Description of Type Design Change: Installation of a Parachute Deployment Static Line Attachment System in accordance with U.S. Forest Service Specification and Installation Instructions; and Drawing MEDC-617, Sheets 1 and 2.

SPECIFICATION AND INSTALLATION INSTRUCTION
FOR SMOKEJUMPER STATIC LINE ANCHOR CABLE FOR
BEECHCRAFT MODELS 90, 99, 100, AND 200 SERIES AIRCRAFT

We have satisfactorily completed our review of your drawing, MEDC-617, revision D, sheets 1 and 2.

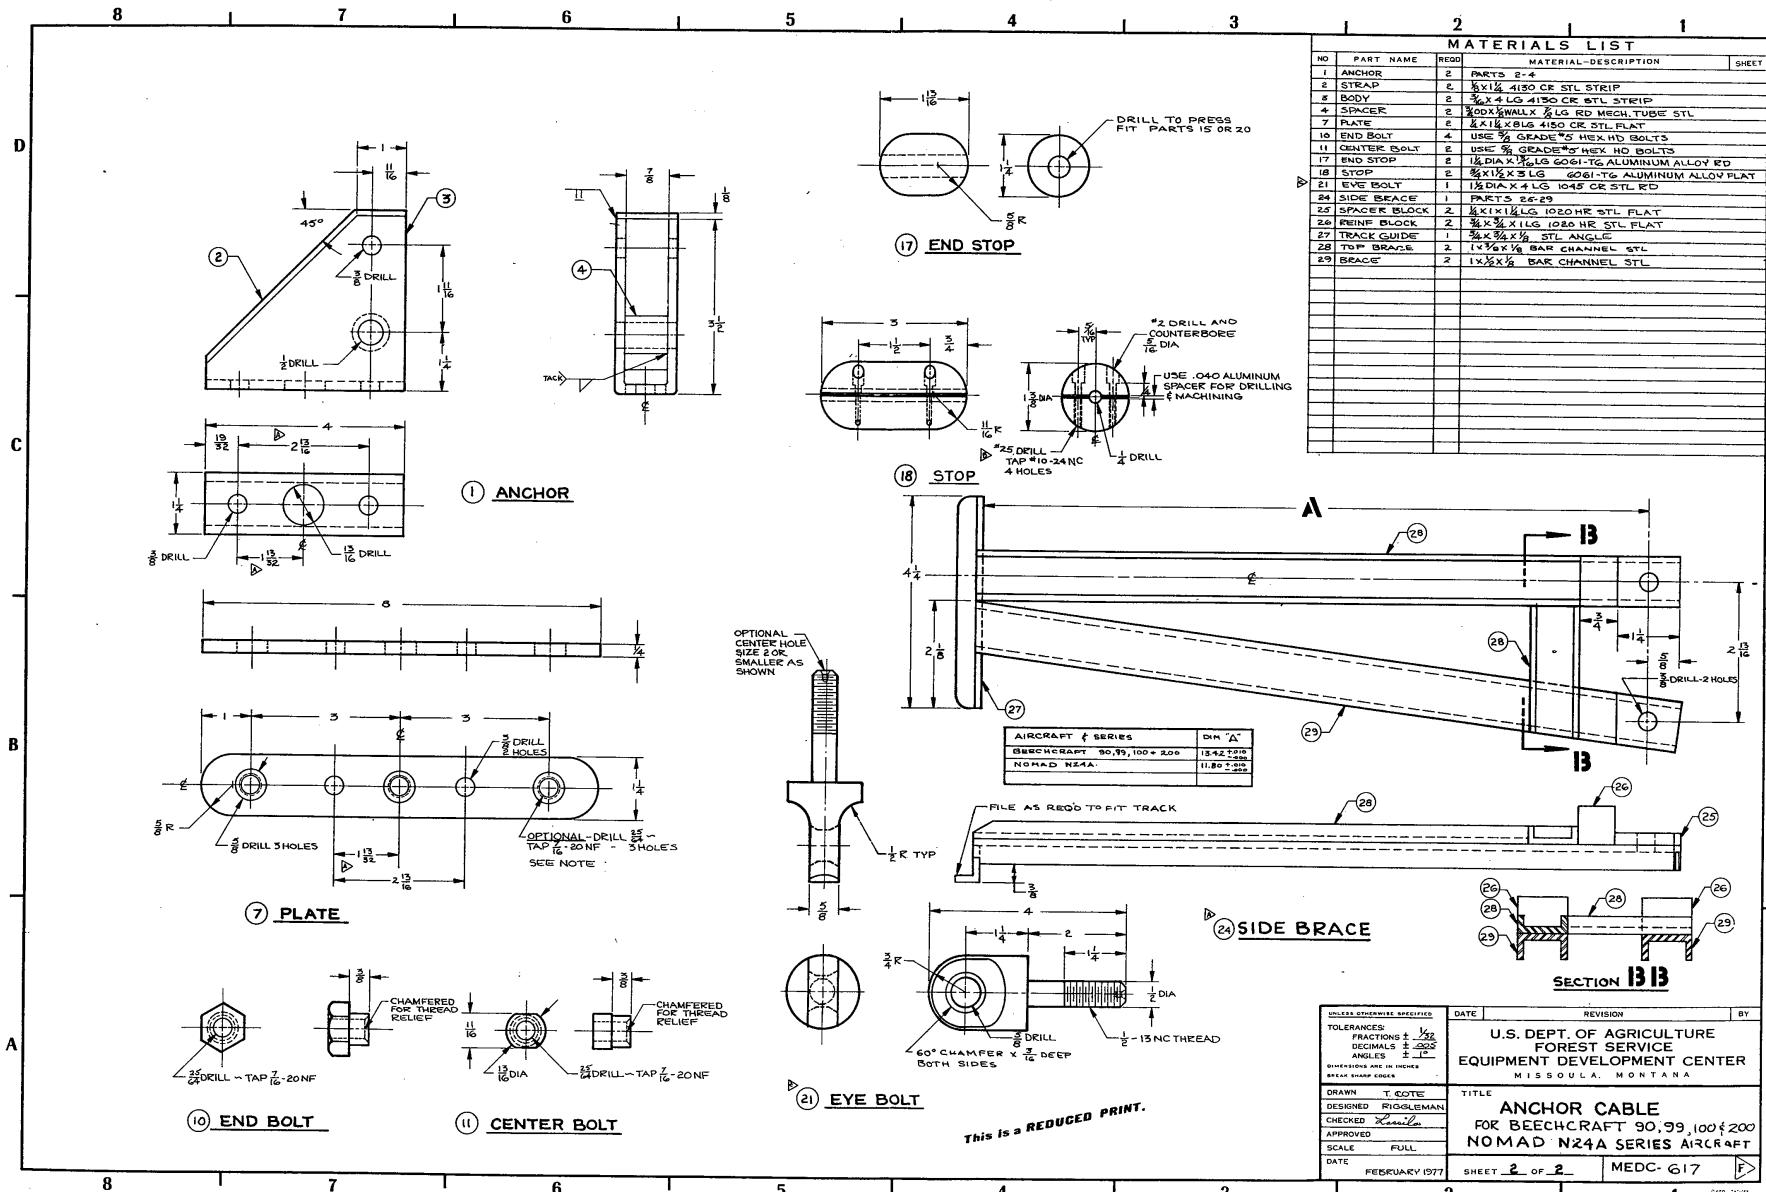
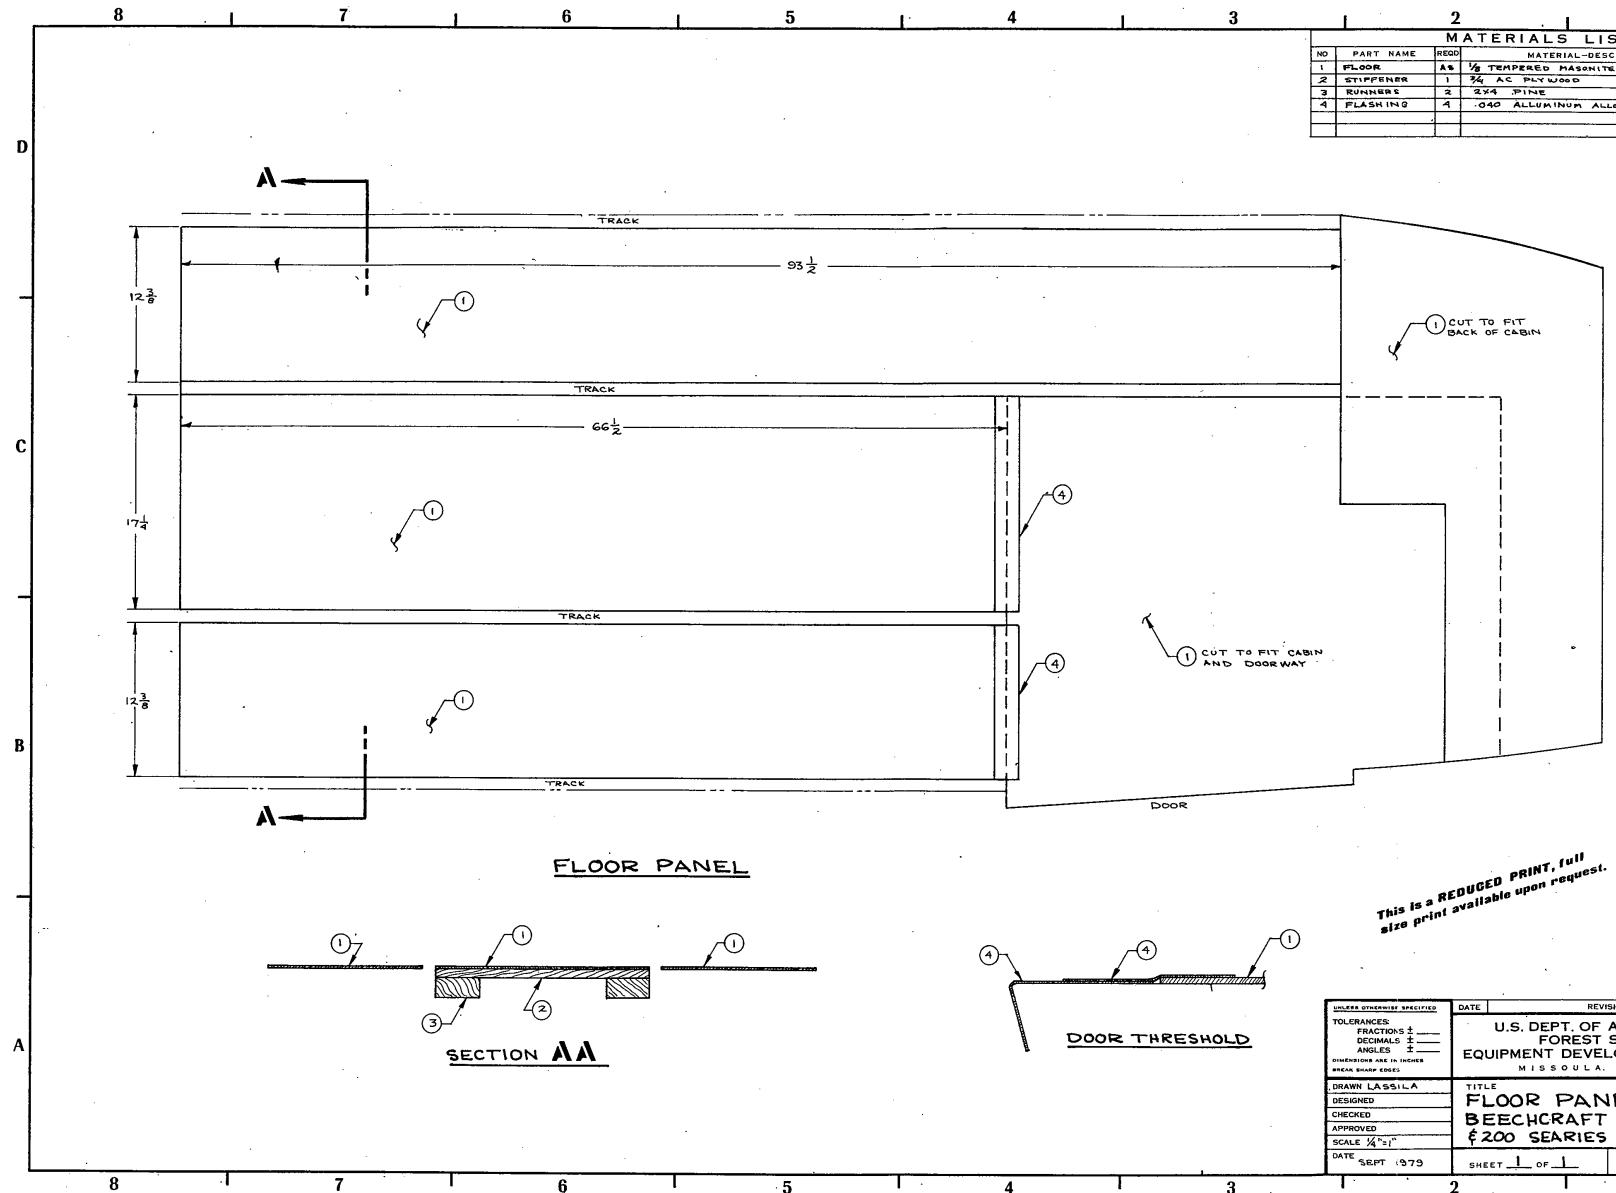
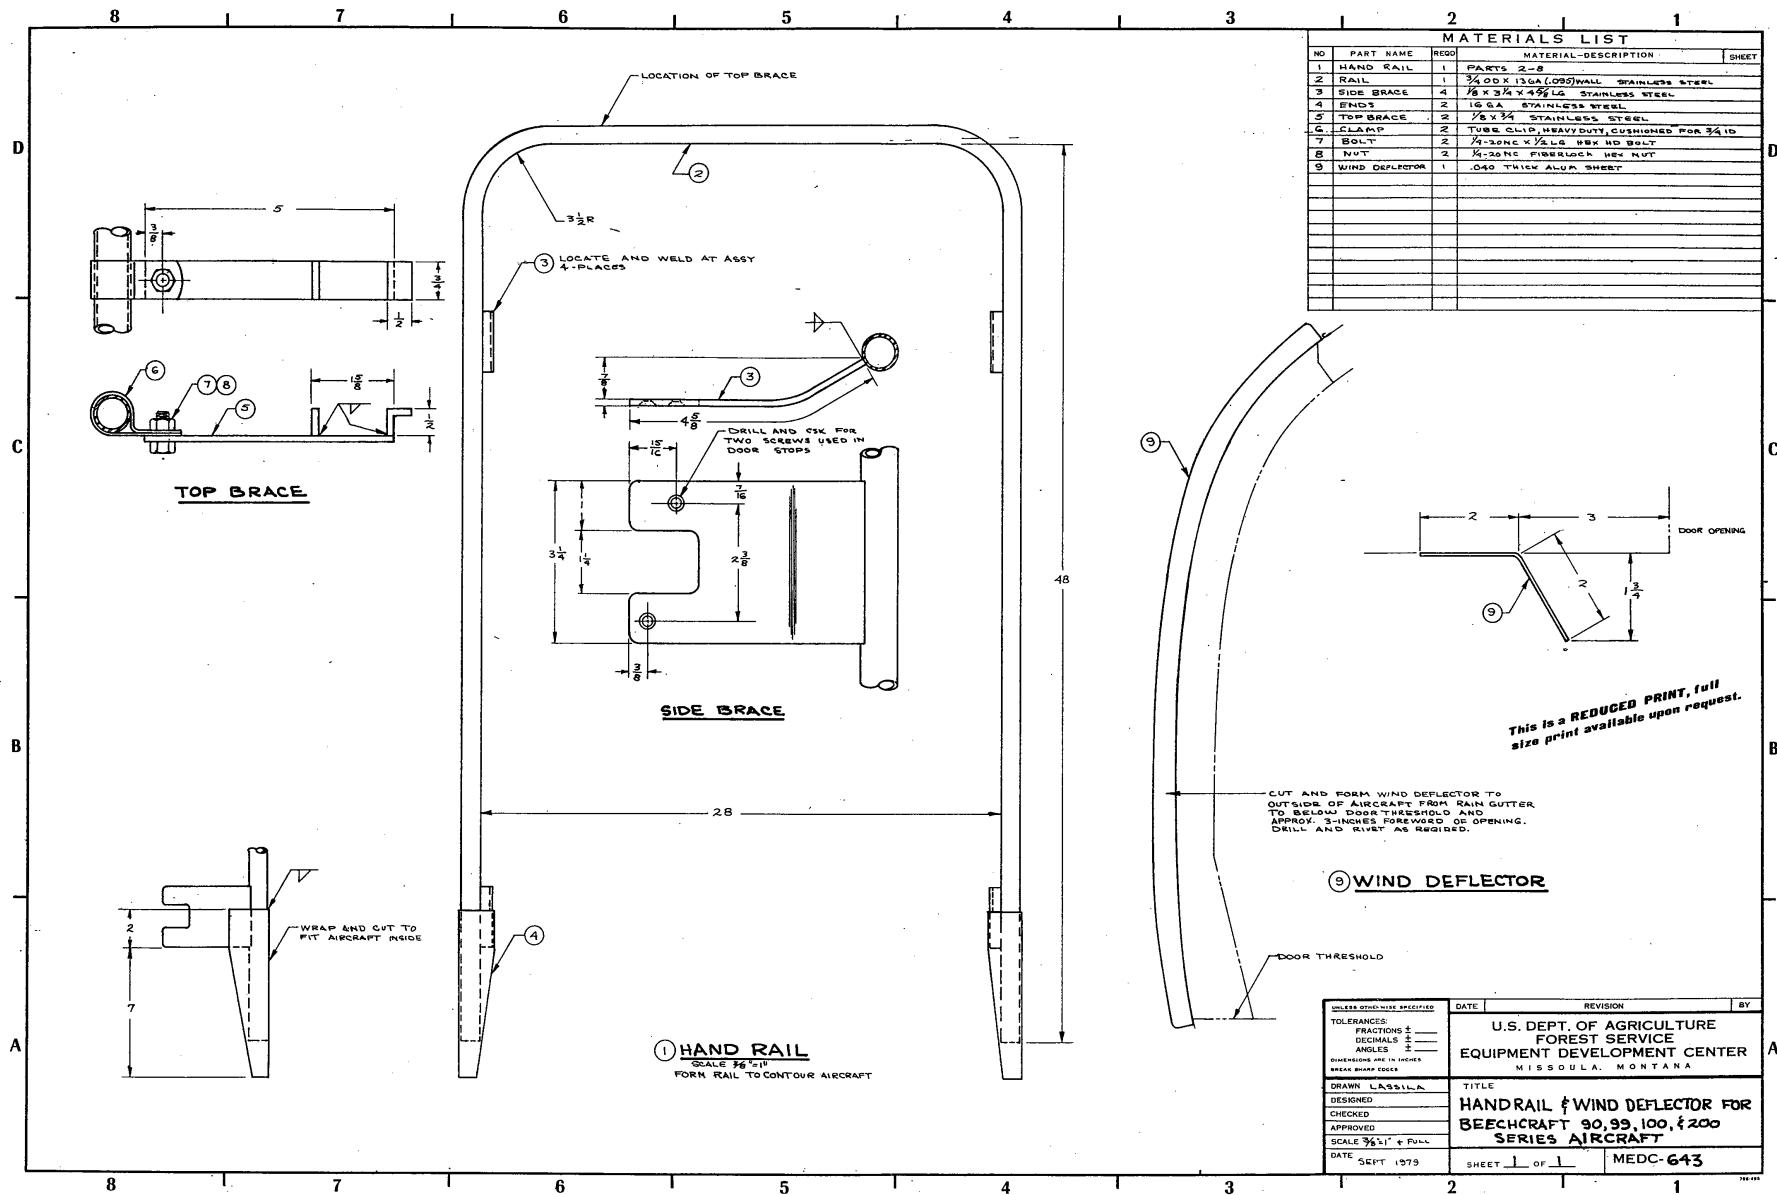
Sheet 1 has been revised since the issuance of the amendment to Supplemental Type Certificate (STC) SA566NW, dated July 14. This revision added the length of the anchor cable and changed Note 3 to increase the cable assembly slack from 4 to 6 inches. This change on the drawing necessitates an amendment to the Specification and Installation Instruction.

Parts are fabricated as illustrated in drawing MEDC-617 sheets 1 and 2. All welding is by the arc process. Assembled anchor units are installed in the aircraft right hand seat track with the one using Part 24, side brace, placed opposite the door used for jumper deployment. Cable length between anchors shall be 76 1/2 inches. The cable assembly shall be installed with 6 inches of slack measured in extreme spread. Part #18, the cable stop, must be adjusted along the length of the cable so the parachute deployment bag cannot trail aft of the horizontal stabilizer.
